TYPE III –Master Plan and Detailed Development Plan STAFF REPORT AND RECOMMENDATION

FILE NUMBER: CP-17-0002: General Development (Concept) Plan
DP-17-0003: Detailed Development Plan for Phase 1
NR-17-0004: Natural Resource Overlay District Verification

REQUEST: Approval for General Development Plan for Abernethy Place, a mixed-use project including Hotel, Multi-Family, Retail/Commercial and Office Use to be constructed in two phases over 10-years as well as a Detailed Development Plan for Phase 1 which includes construction of a Hotel and parking lots.

East (Washington Street) façade.

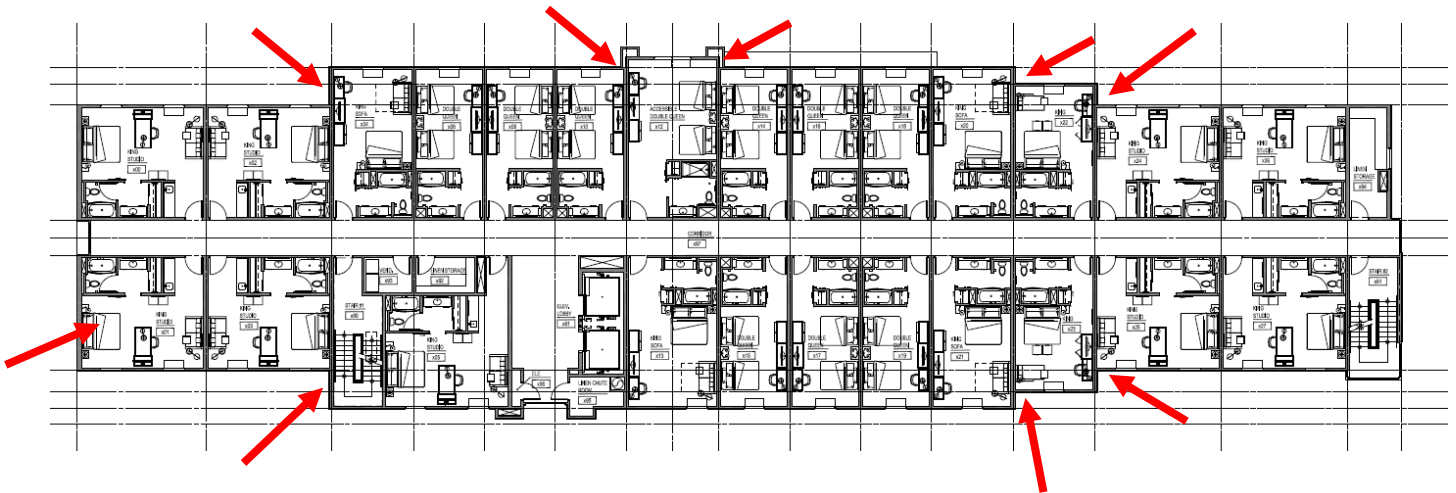
Finding: Complies as proposed. The applicant has proposed substantial variations in the hotel building massing to reduce horizontal building mass, including projecting elements (porte cochere, Washington Street stair tower, south building entry), recessed Washington Street entry, and variation in building parapet heights. The standard requires a variation to the height and projecting or recessed elements every 179 feet based on a height of 59'8" (59'8" * 3 = 179') as measured from the base flood elevation.

The following diagram illustrates the locations of the proposed massing variations for the facades that exceed the height-to-width ratio on the Washington Street elevation (variations indicated in yellow dashed ellipses with the measurements in red).

Massing changes have been incorporated to reduce building mass and scale in locations most frequented by pedestrians.

GDP Drawing PP2 - Preliminary Grading Plan

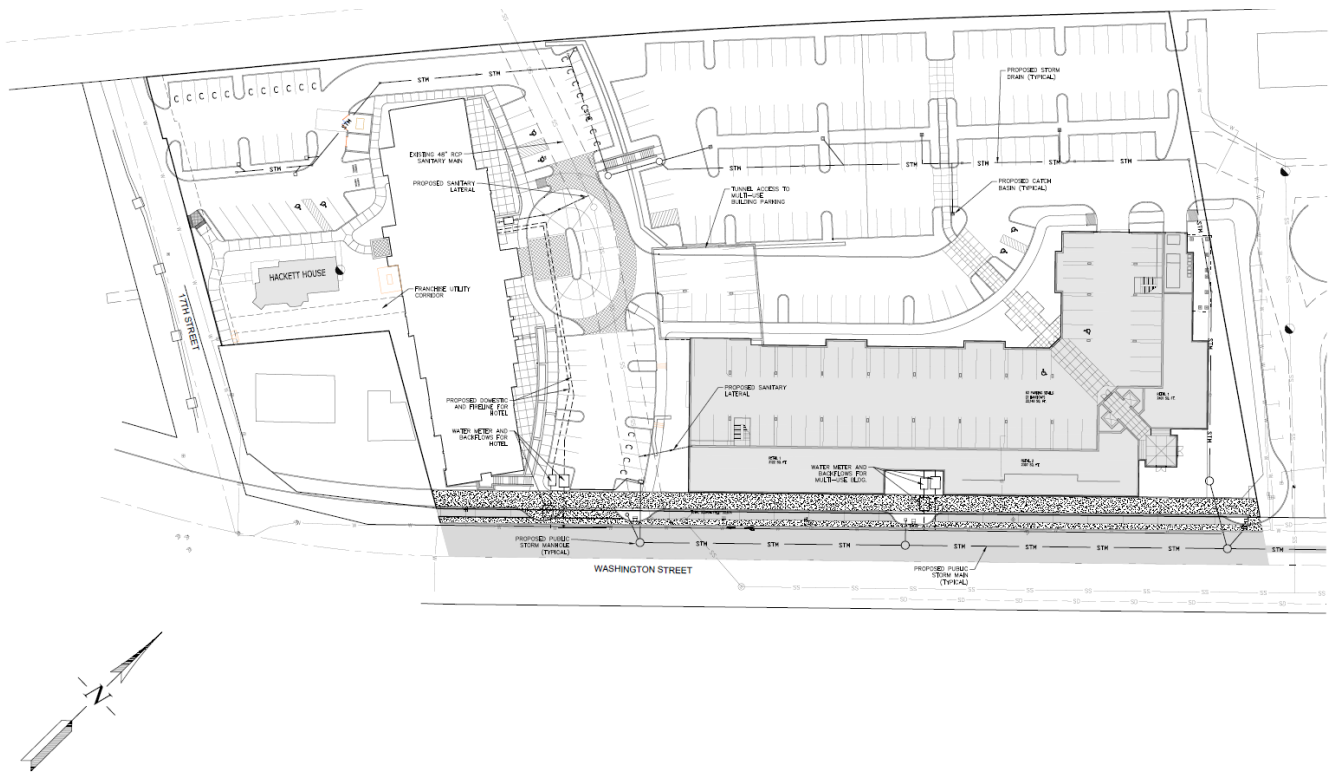
Finding: Complies with Conditions. The proposed development does not qualify for an abbreviated grading plan. An engineered grading plan and geotechnical report are required, and the applicant has submitted preliminary materials. A condition will be applied to ensure complete materials are submitted and approved and that site grading will not commence until all necessary permits have been obtained. **It is reasonable, practicable and likely that this standard can be met through the conditions of approval.**

15. The applicant shall submit an engineered grading plan and geotechnical report for review and approval prior to approval of public improvement plans.
